Change Notice

PCN No: 144

PCN No: 125

Product Type: AL295

PCN_125_AL295

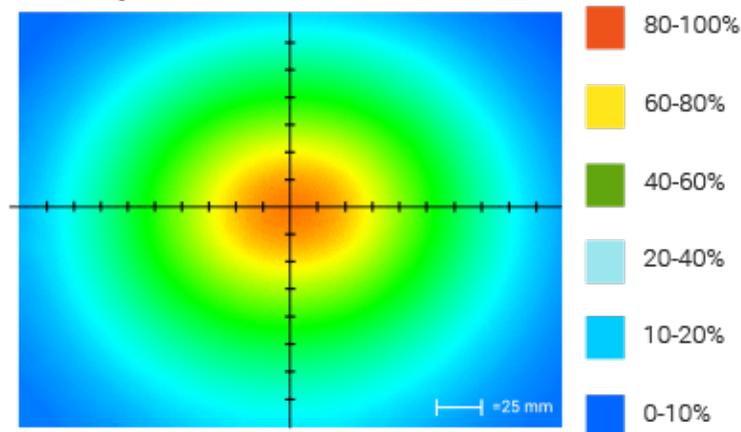
In an effort to improve our products, Advanced illumination (Ai) will update the LEDs used in the AL295 design. This change will result in a brighter, more uniform light at the same price*. Customers may still buy the current revision of this model until September 2th of 2016. After that time, orders for these products will be converted to their respective AL295 Revision A models.

This LED change will result in additional wavelengths being available: 365nm, 375nm, 385nm, 395nm, 405nm, 470nm, 505nm, 590nm, 660nm, 730nm, and 940nm. Additionally the white LED color temperture will be changing from 6100K to 5500K.

*UV wavelengths (365nm, 375nm, 385nm, 395nm & 405nm) will be sold a higher list price, which will be released at the time of product introduction.

Orders for customized (dash numbers) versions of AL295 will be honored until January 13th of 2017. Ai will be actively working with customers for those products to simplify the transition.
